A REPAIR

SEWAGE DISPOSAL SYSTEM

MARYLAND STATE DEPARTMENT OF HEALTH

ADDRESS 12200 Triadelphia Road, Ellicott City, Maryland PHONE 988-9764

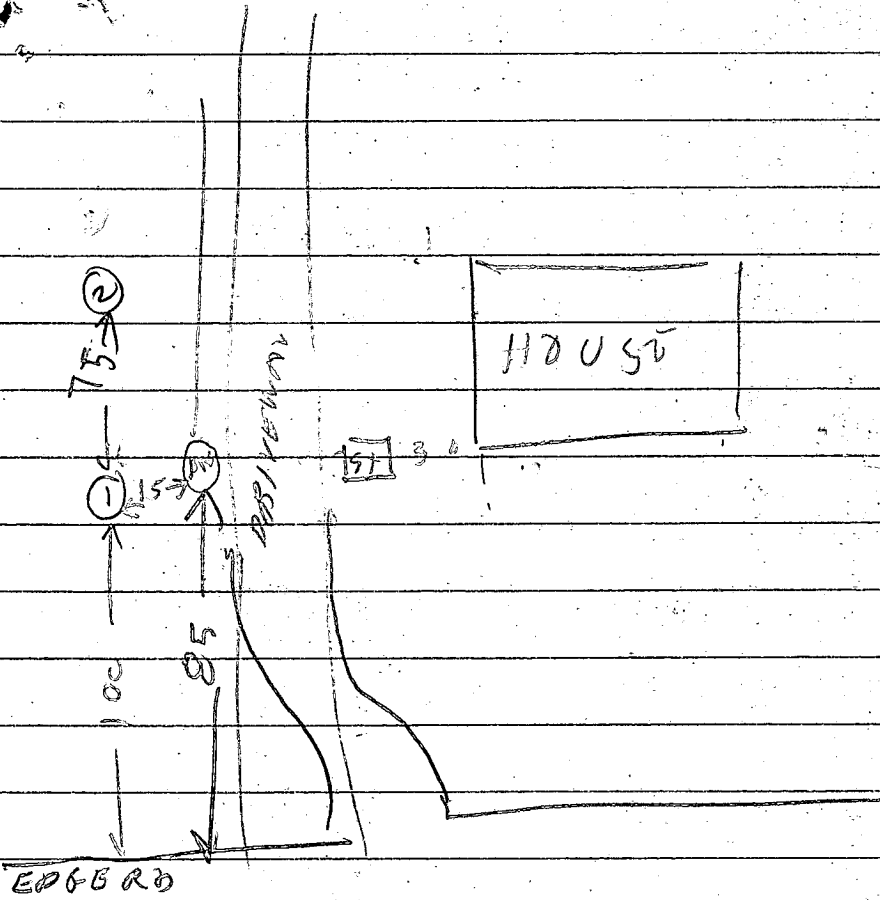
REMARKS TALKED TO ALLEN MITCHEL 3/2/83 SEE ATTACHED

LINE SHEET. 3/3/83 LOCATION OK

DITCH OK. TANK SET. ADD STONE & PIPE FINISH

HOOKING UP NEW TANK R.H. 3/4/83 STONE ADDED

TO DITCH, NEW TOP ON OLD DRY WELL. OLD PIPES

HOUSE TO TANK, TANK TO DW RE PLACED. OLD STEEL TANK REMOVED

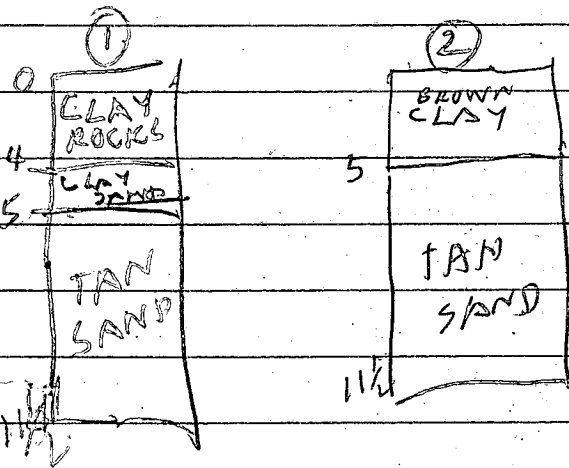
3) 2/83 VISUAL HOLES DUG

DECIDED TRENCH
SYSTEM
SEE PERMIT

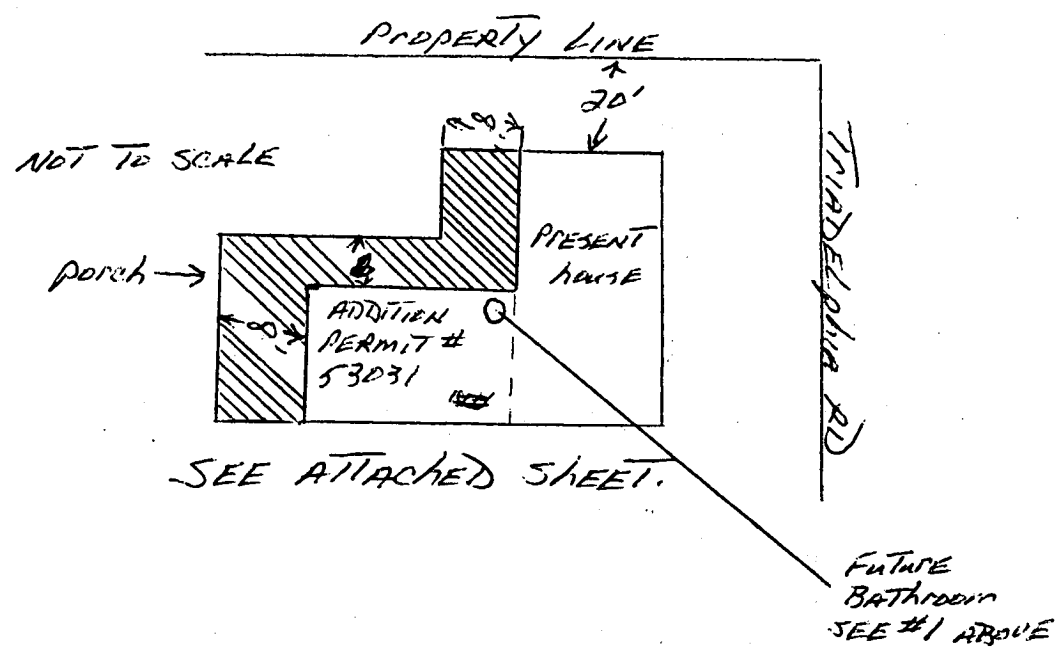
#2. ADD A PORCH PART OF WHICH WILL CONNECT
PRESENT HOUSE TO ADDITION. SEE DIAGRAM:

Third District, Howard County, Md.
 Scale 1"=50' Aug. 28, 1959
 Ralph O. Snyder
 Registered Surveyor
 Ellicott City, Md.

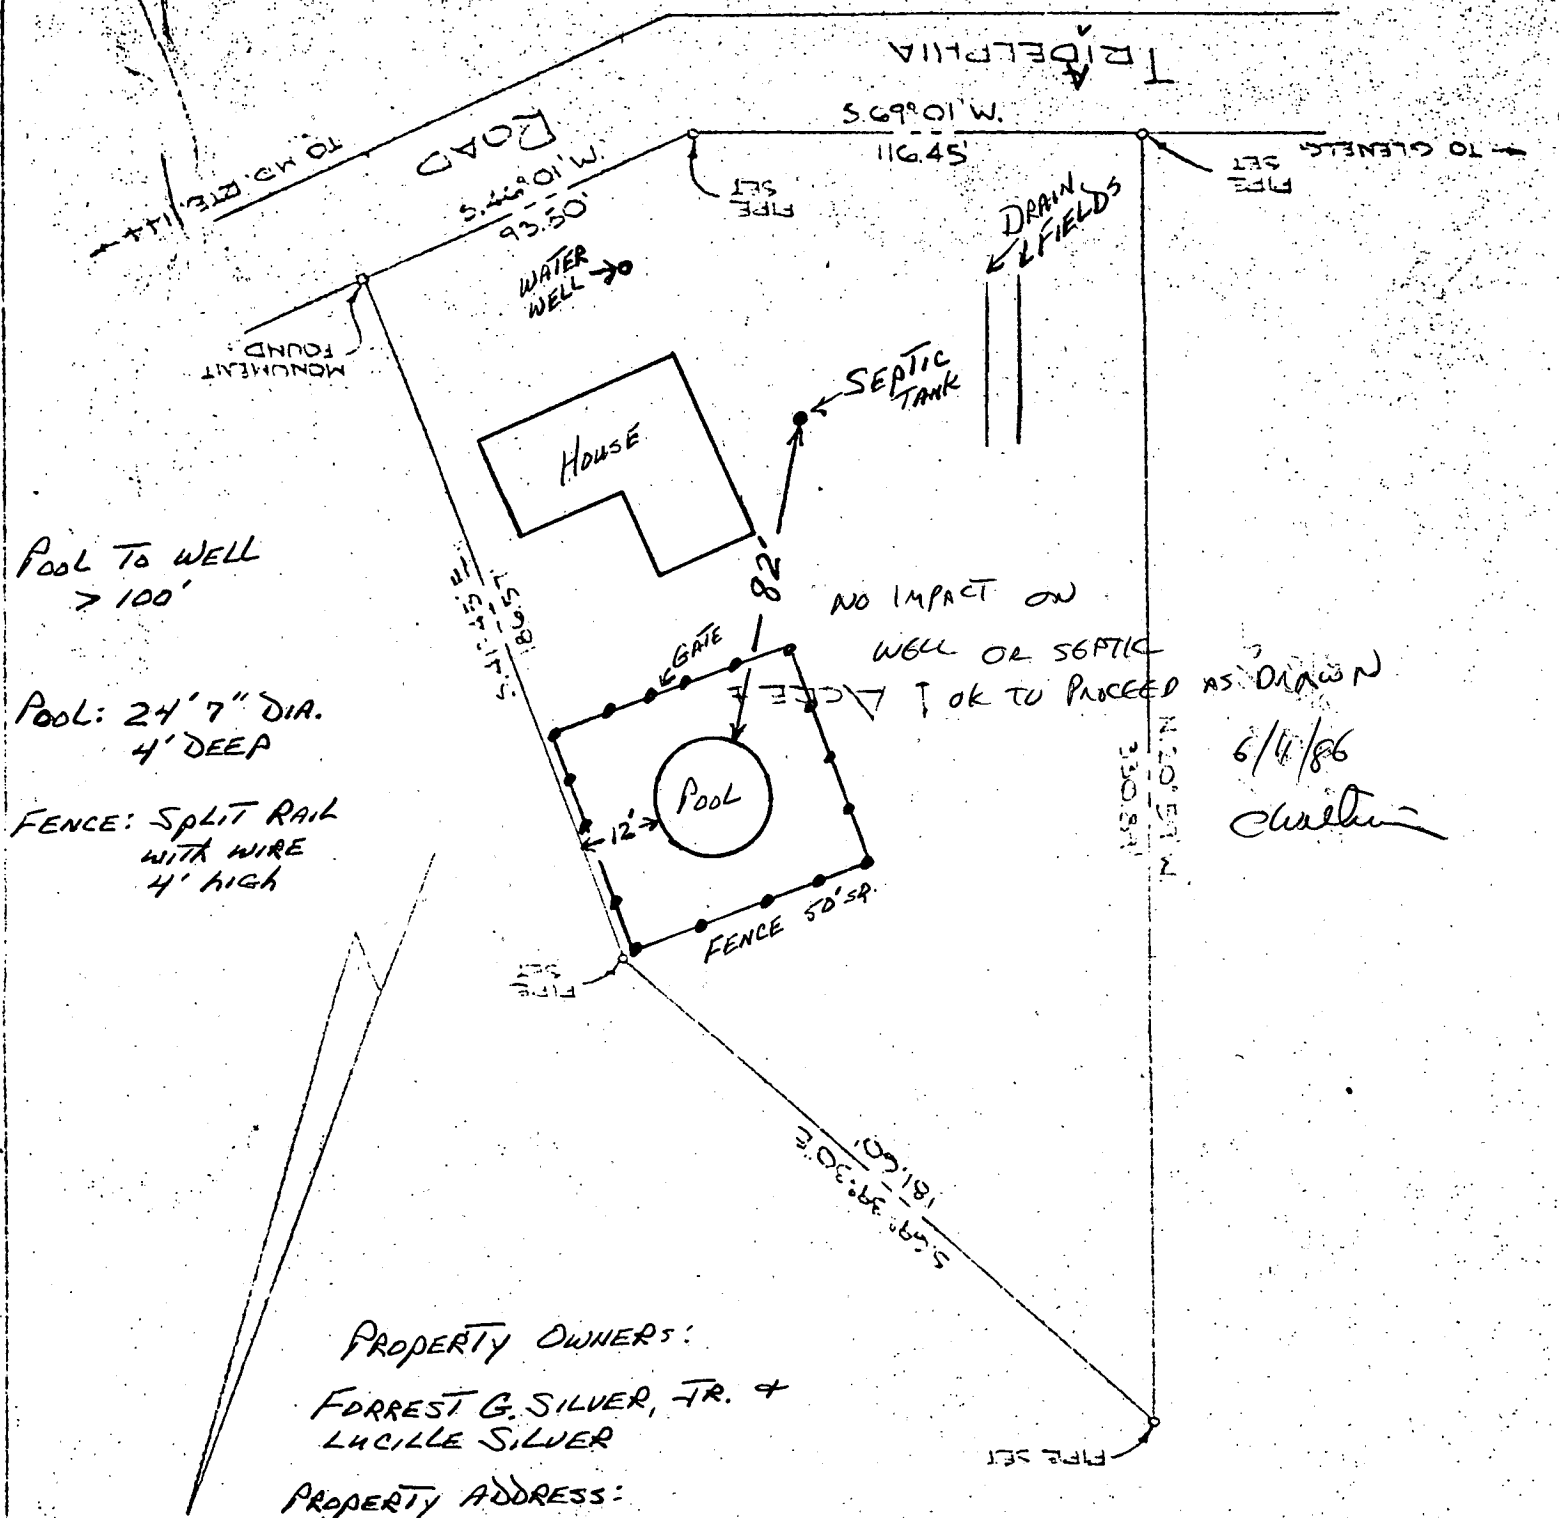
Pool To Well
 > 100'

Pool: 24' 7" DIA.
 4' DEEP

FENCE: SPLIT RAIL
 WITH WIRE
 4' HIGH

NO IMPACT ON
 WELL OR SEPTIC
 TANK TO PROCEED AS DRAWN
